World Forum for Harmonization of Vehicle Regulations**Working Party on General Safety Provisions****125th session**

Geneva, 27–31 March 2023

Event Data Recorder:**UN Regulation No. 160 (Event Data Recorder)****Proposal for Supplement 2 to the Original Version of UN
Regulation No. 160 (Event Data Recorder)****Submitted by the expert from the Informal Working Group on Event
Data Recorder / Data Storage System for Automated Driving ***

Corridor +/- 10 Per Cent of the Full-Scale Range of the Accelerometer

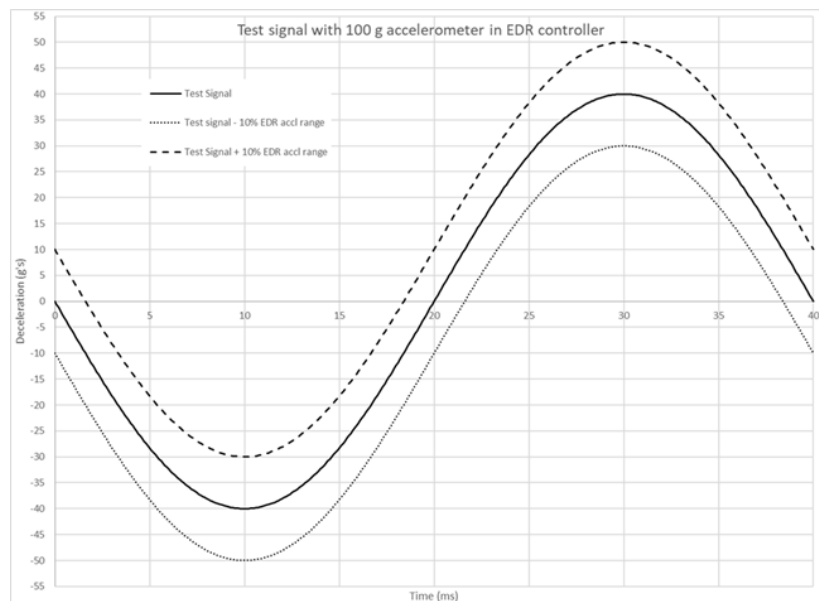
- 6.1.5. The EDR recorded acceleration trace shall be fully contained in a corridor that is +/- 10 per cent of the full-scale range of the accelerometer used by the controller containing the EDR applied to the component test fixture's filtered acceleration trace. The comparison of acceleration sensor traces shall only be made on the axis the component test was conducted.

For example, if the accelerometer in the controller containing the EDR function has a +/- 100 g range, then +/- 10 g would be applied to the component test fixture's filtered acceleration trace. The EDR recorded acceleration trace shall be fully contained within that corridor (see the Figure).

- 6.1.6. **The EDR acceleration trace in paragraph 6.1.5. can be time shifted up to +/- 2ms based on the inverse of the 500 Hz sample rate to further align the data. The minimum step of the time shift may be the inverse of the sample rate of the EDR.**
- 6.1.7. **The acceleration data elements satisfy the tolerance condition if the EDR recorded acceleration trace is fully contained within the corridor established in paragraph 6.1.5., with or without following the above time shift in paragraph 6.1.6.**
- 6.1.8. **If the recommended waveform cannot realize algorithm wakeup due to the reason of manufacturer’s algorithm strategy, the manufacture may select a waveform, or amplify the suggested waveform. The waveform used for the EDR acceleration data accuracy shall be provided for review, if it is different than the waveform defined in the verification process."**
